STAFF RECOMMENDATION
1312 Shelton Avenue
December 18, 2019

Application: New Construction—Addition; Setback determination
District: Inglewood Place Neighborhood Conservation Zoning Overlay
Council District: 7
Base Zoning: RS7.5
Map and Parcel Number: 07207002800
Applicant: Kaitlyn Smous, Nine Twelve Architects
Project Lead: Paul Hoffman; paul.hoffman@nashville.gov

Description of Project: This application is for construction of a rear addition and screened porch at the rear of the existing residence. The applicant requests a setback determination for the addition's right side, from five feet (5') to four feet, three inches (4'3"). **Recommendation Summary:** Staff recommends approval of the project with the following conditions: **1.** Staff approve the windows prior to purchase and installation; and, **2.** HVAC and other utilities are located on the rear façade, or beyond the midpoint of the house on a side façade. With these conditions, staff finds that the project meets Section II.B for New Construction in the Inglewood Place Neighborhood Conservation Zoning Overlay.	**Attachments** **A:** Photographs **B:** Site Plan **C:** Elevations

Figure 3: Window to be moved on east elevation.

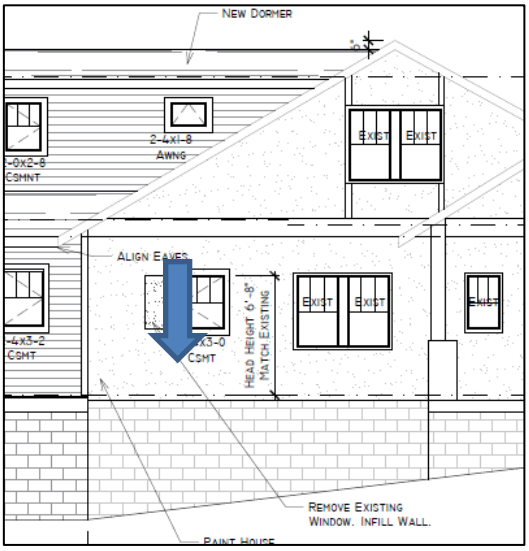
An existing rear deck and approximately fourteen feet (14') of the rear wall will be removed for the new addition. The removal of this portion of the rear wall will not impact the architectural significance or character of the house. One window opening on the house's left side will be moved two feet (2') to the right. This proposed window relocation is at the rear of this side of the house and in a minimally-visible location.

Proportion and Rhythm of Openings**:** One existing window opening on the house is proposed to be moved two feet (2') to the right (see Partial Demolition). No further changes to the window and door openings on the existing house are indicated on the submitted plans. The windows on the proposed addition are generally twice as tall as they are wide and are compatible with the proportion of historical window openings. There are no large expanses of wall space without a window or door opening. Staff finds the project's proportion and rhythm of openings meet Section III.G of the Inglewood Place design guidelines.

Staff therefore finds that the proposed partial demolition is appropriate and meets Section V.B.2 for appropriate demolition and does not meet section V.B.1 for inappropriate demolition.

1 SITE PLAN

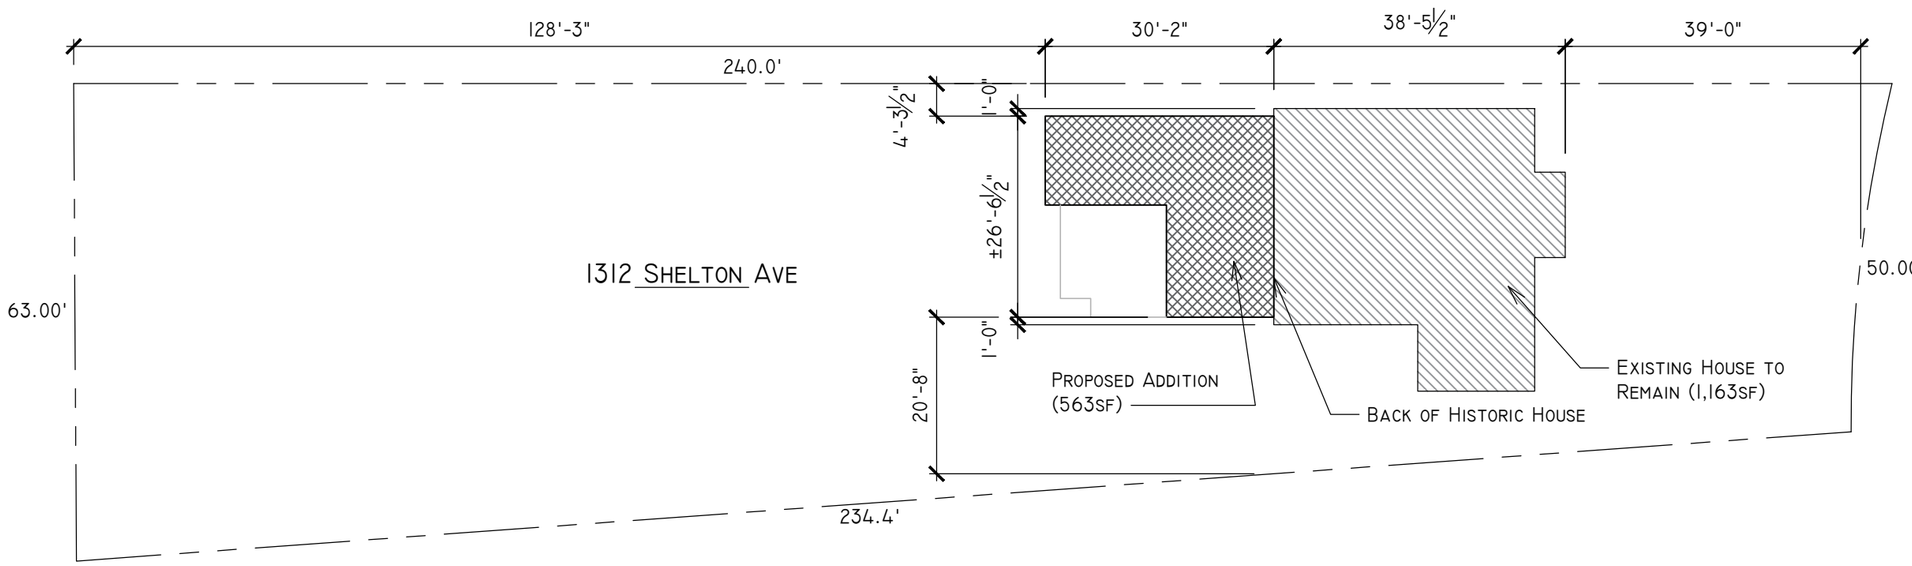
Setbacks & Rhythm of Spacing: The addition will be twenty feet, eight inches (20' 8") from the property's left side, and four feet, three inches (4' 3") from the right side. On the right side, the side wall of the existing house is three feet, three inches (3' 3") inside the side yard setback. The rear setback will be one hundred twenty-eight feet (128') from the rear property line. The addition meets setback requirements for the left and rear. Base setback requirements are five feet (5') from the side property lines, and twenty feet (20') from the rear. The applicant requests a setback determination for the right side, from five feet (5') to four feet, three inches (4' 3"). Staff finds the reduced side setback to be appropriate for several reasons. The addition is narrower than the width of the historic home which already encroaches into the setback area, it will not impact the rhythm of spacing along the block, and the addition is modestly scaled, with an added footprint of just five hundred and sixty-three square feet (563 sq. ft.). Staff recommends approval of the setback determination, and finds that the project's setback and rhythm of spacing meet Section III.C of the Inglewood Place design guidelines.

1 ROOF PLAN

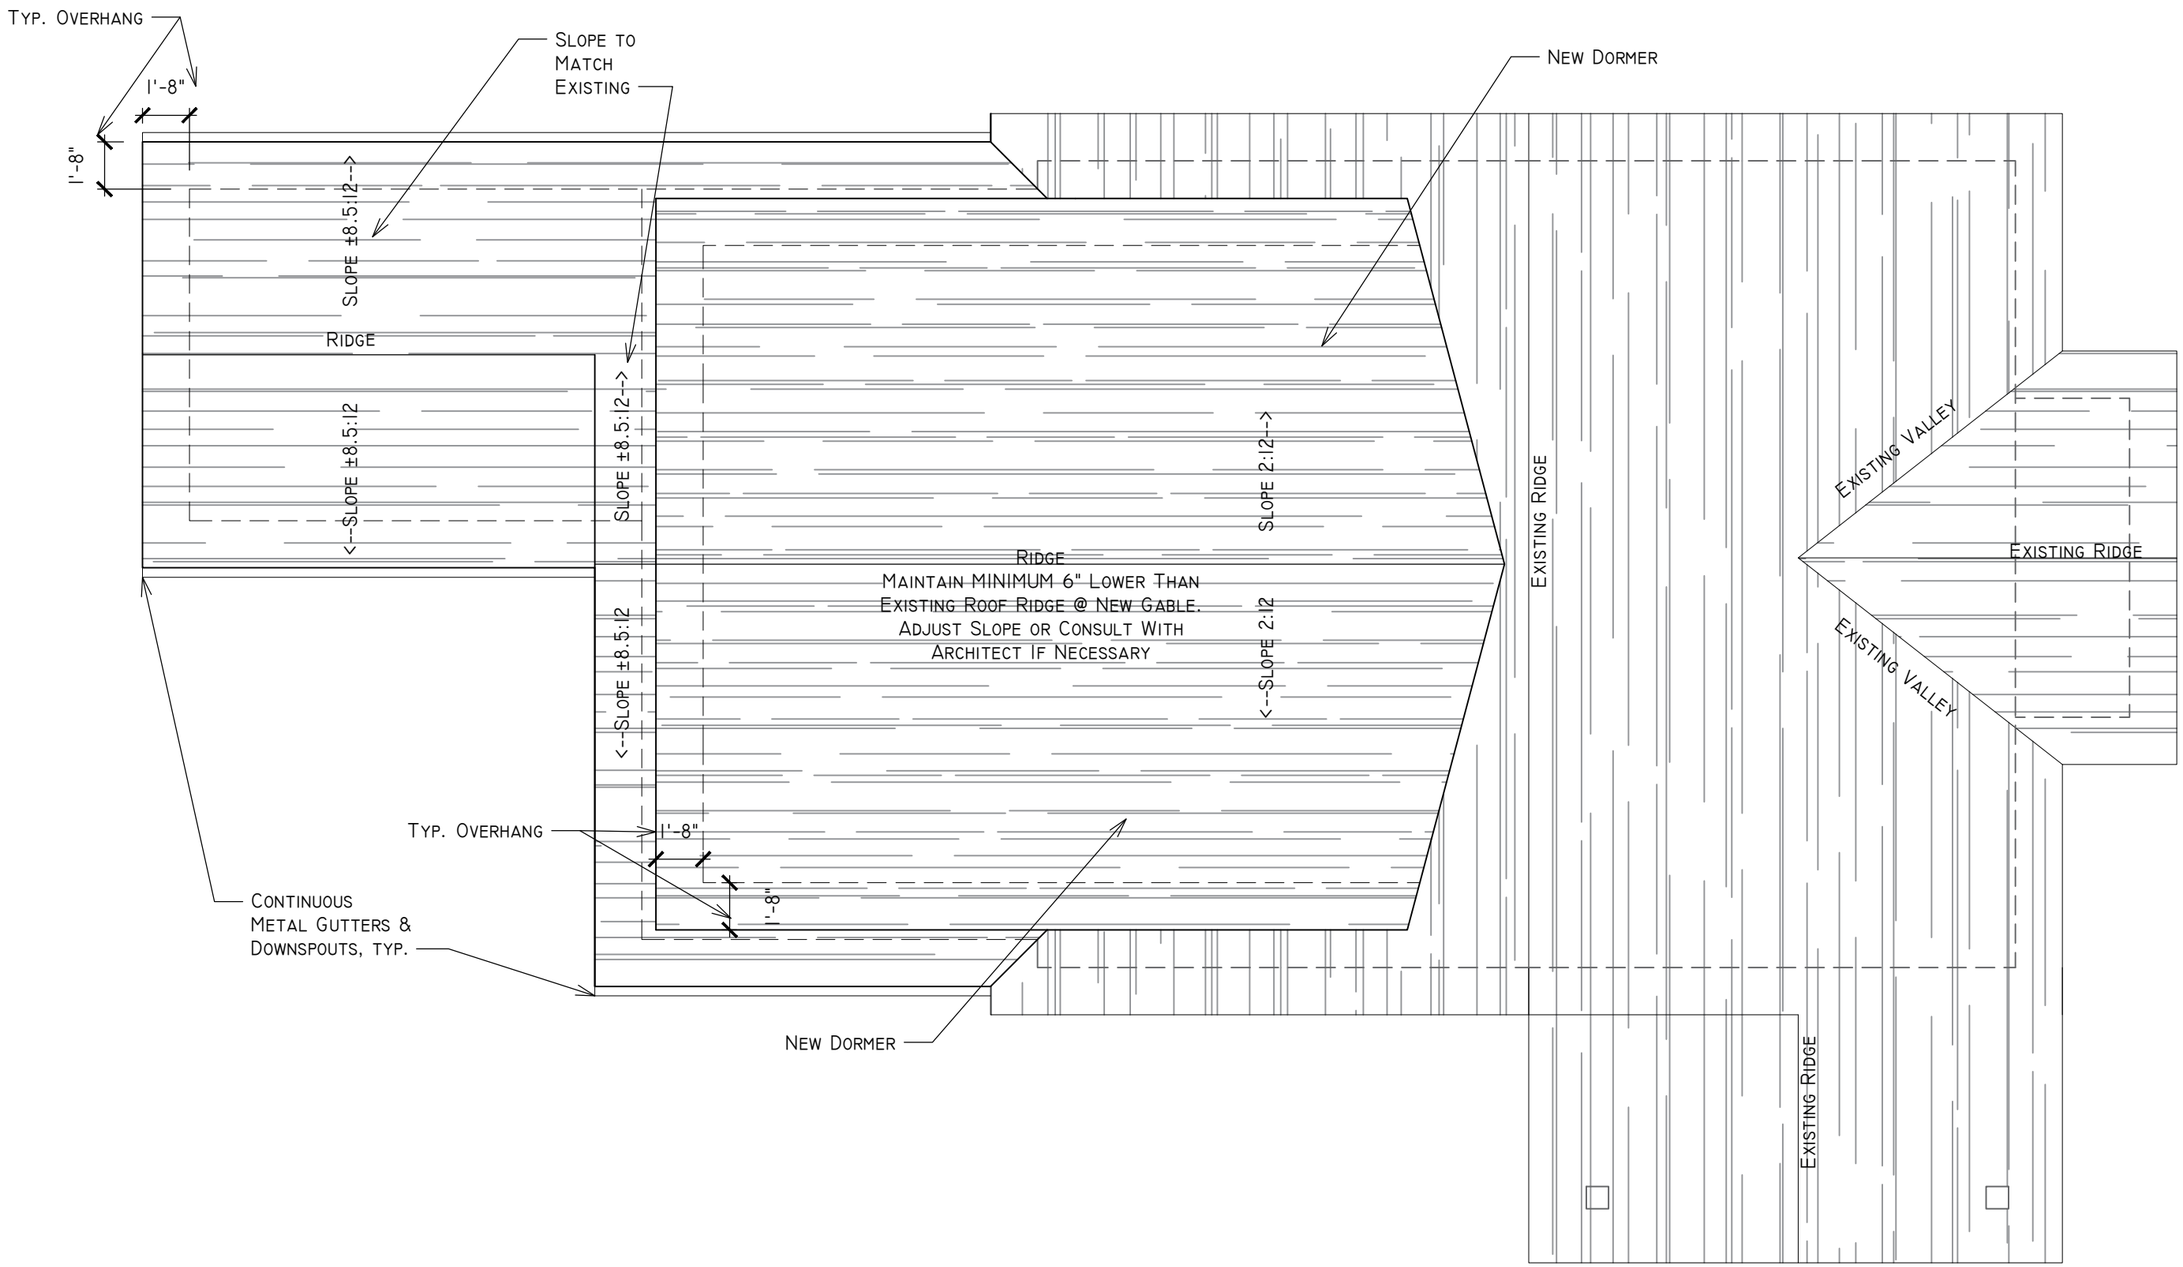
Roof form: The historic home has a side-gabled roof. The addition will have a perpendicular gabled roof with 8.5/12 pitch which connects to the house six inches (6") below the ridge. Each side of the addition has a 2/12-pitched shed dormer. The rear porch roof matches the form and pitch of the addition. The proposed roof forms are appropriate, and staff finds that the project's roof form meets Section III.E of the Inglewood Place design guidelines.
